# UNITED STATES PATENT AND TRADEMARK OFFICE

<b>Office Action Summary</b>	Application No. 10/713,548	Applicant(s) CHEN ET AL.	
	Examiner Ricky L. Mack	Art Unit 2873

## **DETAILED ACTION**

FIG. 3

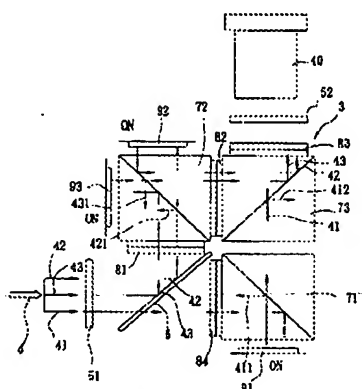
Chuang discloses, as in claims 1, 8, 10, 12, 17, 19 and 20, a color management architecture comprising for managing red, blue, and green primary colors from a substantially white input light (4), the architecture comprising: an input dichroic beam splitting element (6) configured to split the input light into a first portion and a second portion (see fig. 3), wherein the first portion contains a first substantially non-green primary color from the input light and wherein the second portion contains a second substantially non-green primary color from the input light and a substantially green primary color from the input light; a first polarizing beam splitter (71) configured to receive the first portion light containing the first substantially non-green primary color from the input dichroic beam splitting element (6); a first reflective panel (91) adjacent to the first polarizing beam splitter (6) and configured to modulate and reflect the first portion light; a second polarizing beam splitter (72) configured to receive the second portion light and to split the second portion light into a third portion light containing

the second substantially non-green primary color and a fourth portion light containing the substantially green primary color; a second reflective panel (93) adjacent to the second polarizing beam splitter (72) and configured to modulate and reflect the third portion light; a third reflective (92) panel adjacent to the second polarizing beam splitter (72) and configured to modulate and reflect the fourth portion light; and a third polarizing beam splitter (73) adjacent to the first and second polarizing beam splitters and configured to combine the modulated and reflected lights of the first, third, and fourth portions to form an output light (whole document relevant) . Chuang discloses a device sufficient in structure to anticipate the limitations cited in claims 1-20. While Chuang does not specifically mention the non-green and green color limitations, applicant does not provide a specific structural limitation, which Chuang does not disclose. Chuang's device provides a broad teaching which is considered to include the specific function, which the present invention claims.

Chuang discloses, as in claim 2, a polarization element (84) between the input dichroic beamsplitter and the 1st polarization beam splitter.

Chuang discloses, as in claim 3, a polarization element (81) between the input dichroic beamsplitter and the 2nd polarization beam splitter.

Chuang discloses, as in claim 4, a polarization element (84) between the input dichroic beamsplitter and the 1st polarization beam splitter, and a polarization element (81) between the input dichroic beamsplitter and the 2nd polarization beam splitter.
